2. Benjamin Bardarson Subdivision 2025 Replat  
KPB File 2025-037  
Peninsula Surveying / Salmon Bake Cabins, LLC  
Location: Herman Leirer Road & Bronze Avenue  
Bear Creek Area

**ITEM #1 - PRELIMINARY PLAT  
BENJAMIN-BARDARSON SUBDIVISION 2025 REPLAT**

<b>KPB File No.</b>	2025-037
<b>Plat Committee Meeting:</b>	April 27, 2026
<b>Applicant / Owner:</b>	Salmon Bake Cabins LLC / Seward, AK
<b>Surveyor:</b>	Jason Schollenberg / Peninsula Surveying
<b>General Location:</b>	Herman Leirer Rd, Seward

**STAFF REPORT**

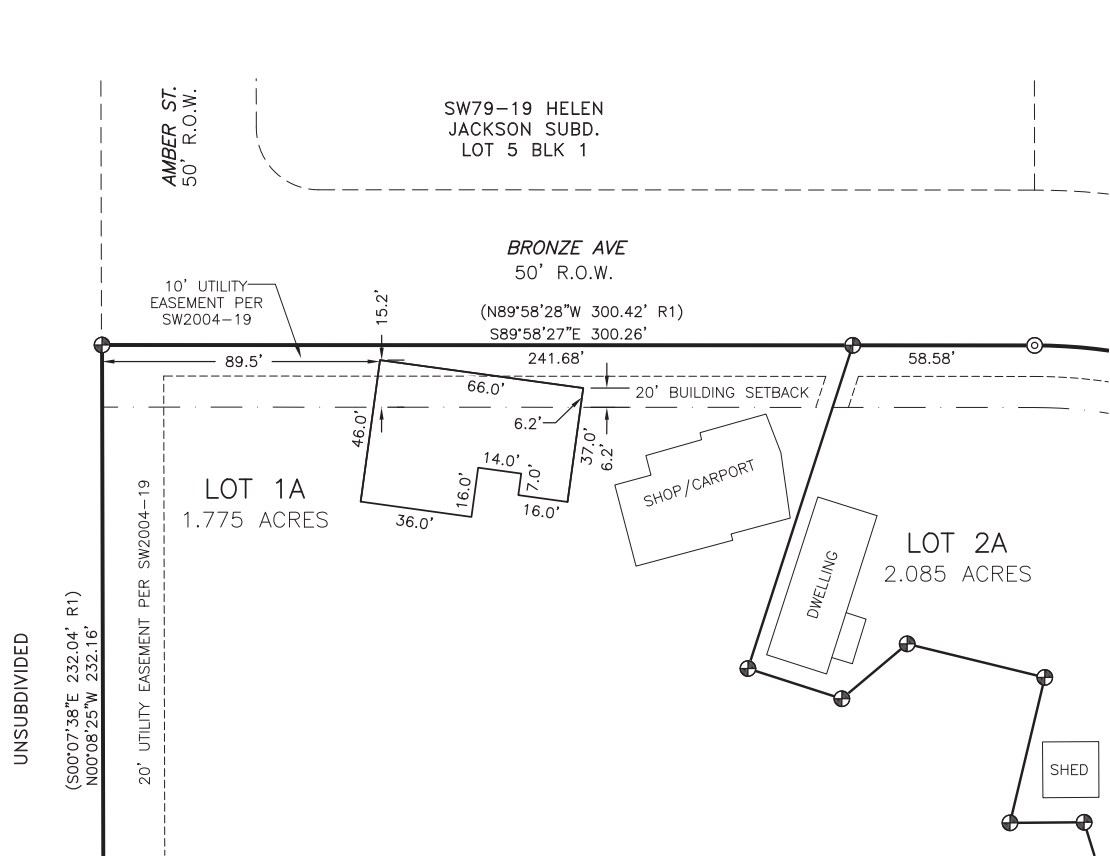
The as-built depicts multiple structures. The approximate 46-foot by 66-foot building located in the northwest portion of Lot 1 Benjamin Bardarson Subdivision SW2004-19 is shown crossing into the 10' utility easement granted by SW2004-19; the surveyor has requested an exception to KPB 20.60.150 for the structure to remain in the location crossing into the 10' utility easement.

1. The building in the northwest portion of the proposed Lot 1A is located ~5.3 into the 10' utility easement per SW2004-19
2. The Staff Report for KPB 2025-037 for the meeting dated April 14, 2025 showed either no comment or no response from any of the utility companies for this area. Considering this, there is no conflict with existing utilities near this building.

6. The northwest corner of the building is approximately 26 feet from the driving surface of Bronze Ave.
7. No utility responded with comment the easement was in use or not.
8. No surrounding properties will be denied utilities with the granting of this exception.

Staff reviewed the exception request and recommends granting approval.
